DAUPHIN COUNTY SUBDIVISION/LAND DEVELOPMENT REVIEW REPORT

Plat Title: Schreffler Family Trust and Tracy R. & Jill S. Troutman

Project Description: Proposed subdivision for 2 side yard additions

PRELIMINARY/FINAL SUBDIVISION PLAN FOR

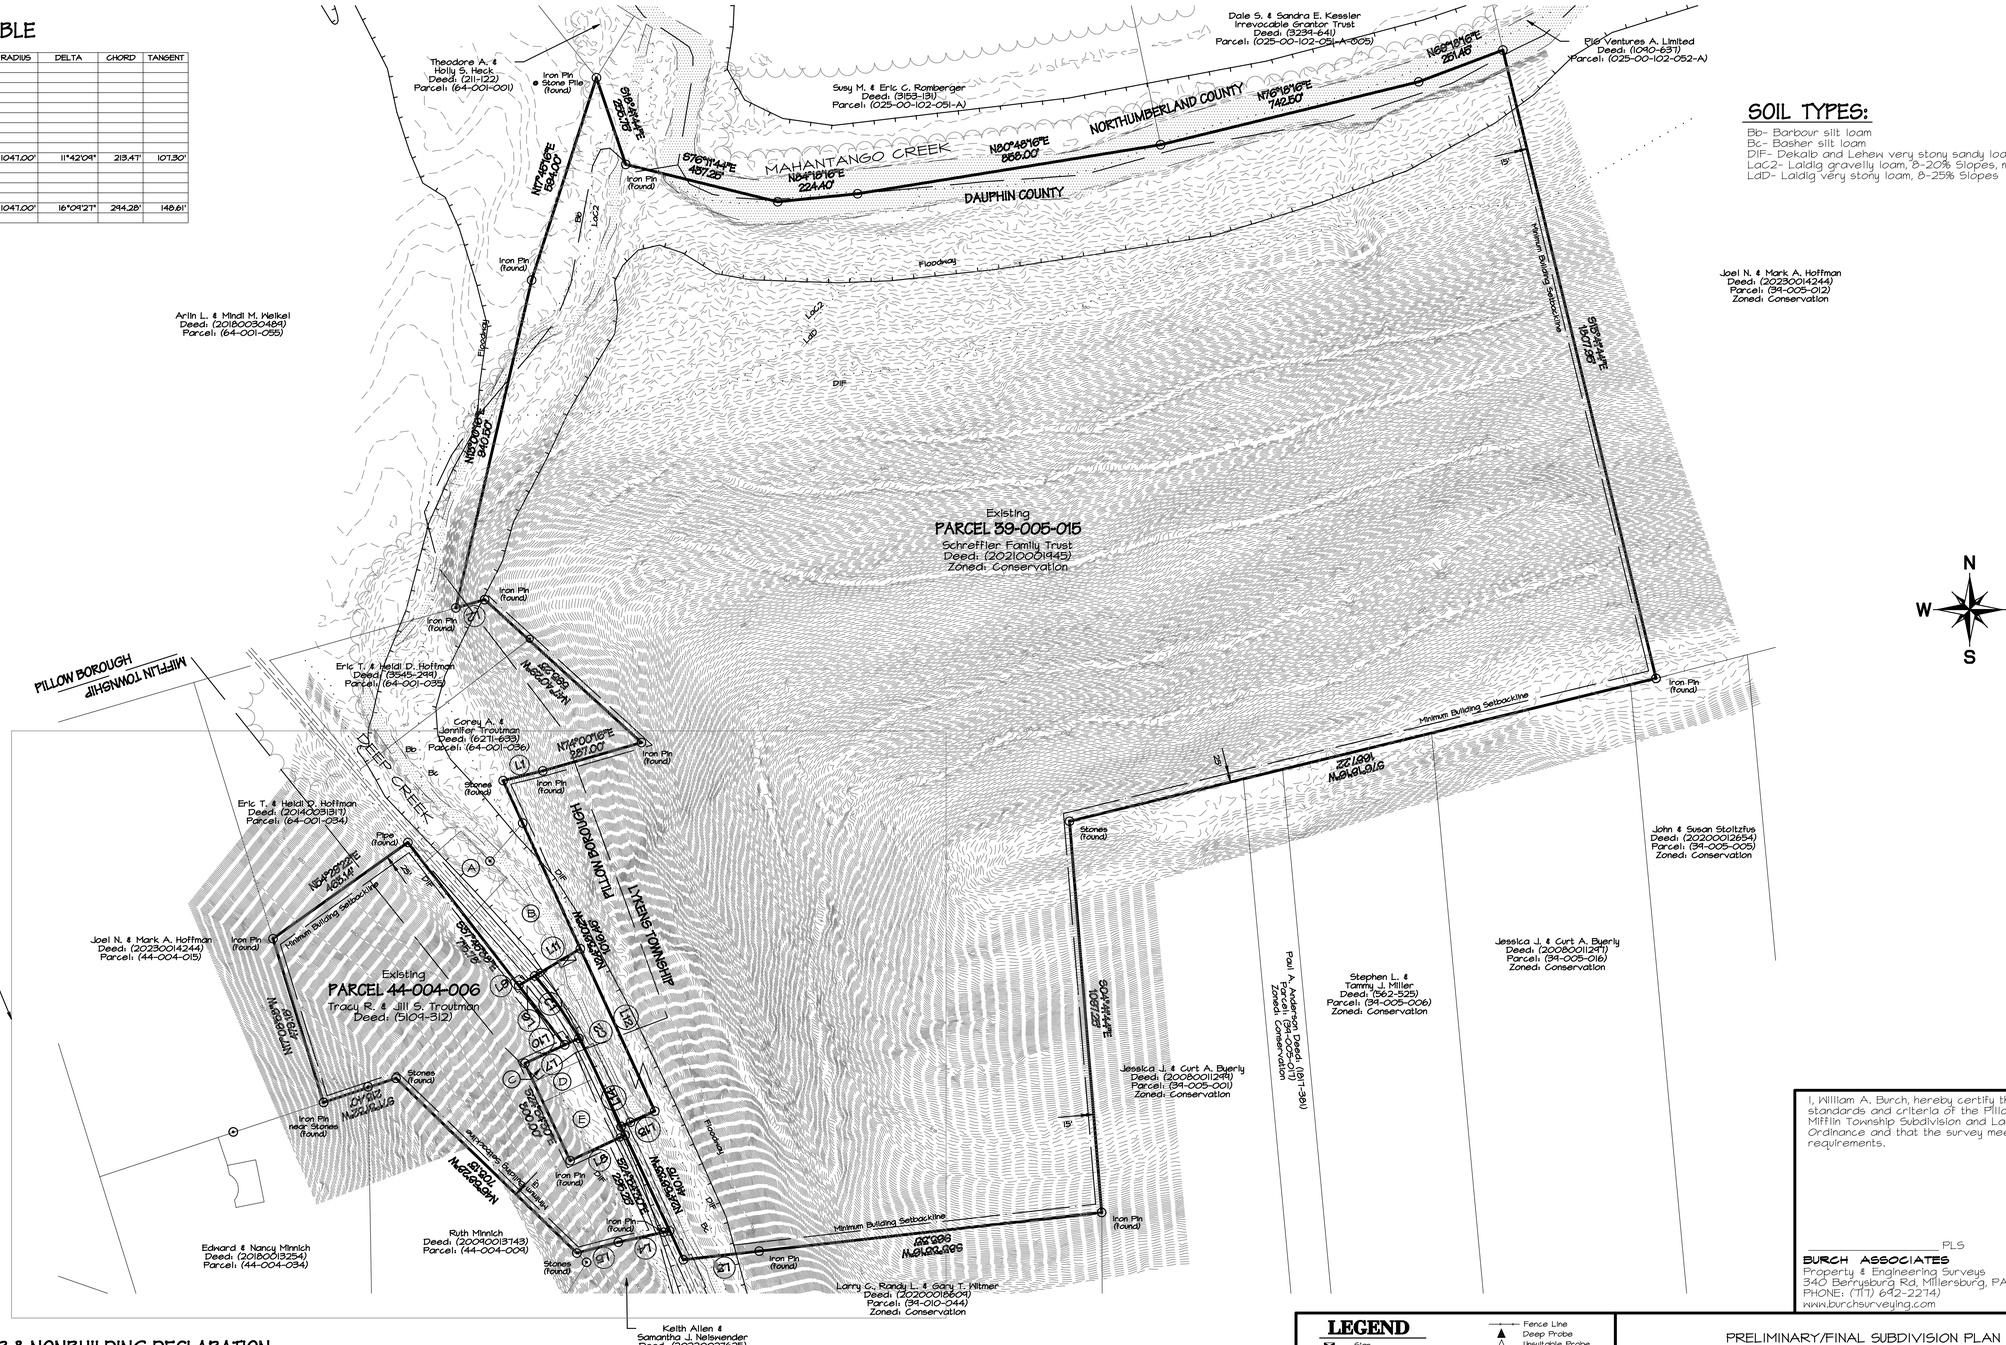
1. The applicant is requesting a waiver of the preliminary plan requirements. (S&LDO §405). This plan has been reviewed as the final plan.
2. Easements are required to be displayed. (S&LDO §407.1.a.4) This includes drainage facilities, overhead and underground facilities, and watercourses.

3. A primary control point is required to be displayed. (S&LDO §407.1.a.1)
4. Locations and descriptions of survey monuments are required to be displayed. (S&LDO §407.1.a.3)

7. The zoning district in which the property is located is required to be displayed. (S&LDO §407.1.a.13) The Hillside/Steep Slope Protection, Wetland Protection Overlay District, and Stream Protection Overlay Districts are not delineated on the plan and should be shown.

8. Wetlands are required to be delineated on the plan. (S&LDO §407.1.a.15)
9. Reference to recorded subdivision plats of adjoining platted land by record name, date, and number is required to be displayed. (S&LDO §407.1.a.18)

11. A State Highway note shall appear on the plat in accordance with S&LDO §407.1.a.20.a. It noted that the plan has a note for Highway Occupancy Permit on the Title Sheet. The language needs to be corrected to read "No building permit will be issued for any lot or parcel which will require access to a State Highway until authorized by a Pennsylvania Department of Transportation Highway Occupancy Permit".

16. Easements for drainage facilities, overhead and underground utility facilities, and watercourses shall be provided in accordance with S&LD §504. The 30-foot easement for Mahantango Creek is required to be displayed.

1. The location of zoning district boundaries should be verified by the Zoning Officer.
2. Existing parcel 39-005-015 contains a SP Overlay District, HSP Overlay district, are required to be shown on the plan in accordance with Article 12, including metes and bounds description, and a conservation easement for the districts shall be provided. (ZO §1202.e, §1203.d, §1205.d)
3. Motor vehicle access shall be in accordance with Article 16 of the Lykens Township Zoning Ordinance.
4. It is noted that Timber Harvesting in the Conservation and HSP Districts is a conditional use ZO Article 4 §404, Article 12 §1203, and must comply with ZO Article 20.
5. Where the average slope of the site exceeds (20%) development is prohibited (ZO §406). What is the average slope of the newly reconfigured parcel?

1. There is no proposed water source for Proposed Area Lot 1A and the existing parcel 39-005-015.
2. There is no proposed access to the newly reconfigured parcel 39-005-015. Direct access from SR 225 would require going over a stream and floodplain.
3. Clarification on the front yard setback should be displayed on the plan to ensure compliance with the ZO. The plan indicates on the Title Sheet, under Site Data, that the front yard setback is "40/30".
4. There should be new proposed lot numbers for the reconfigured lots.
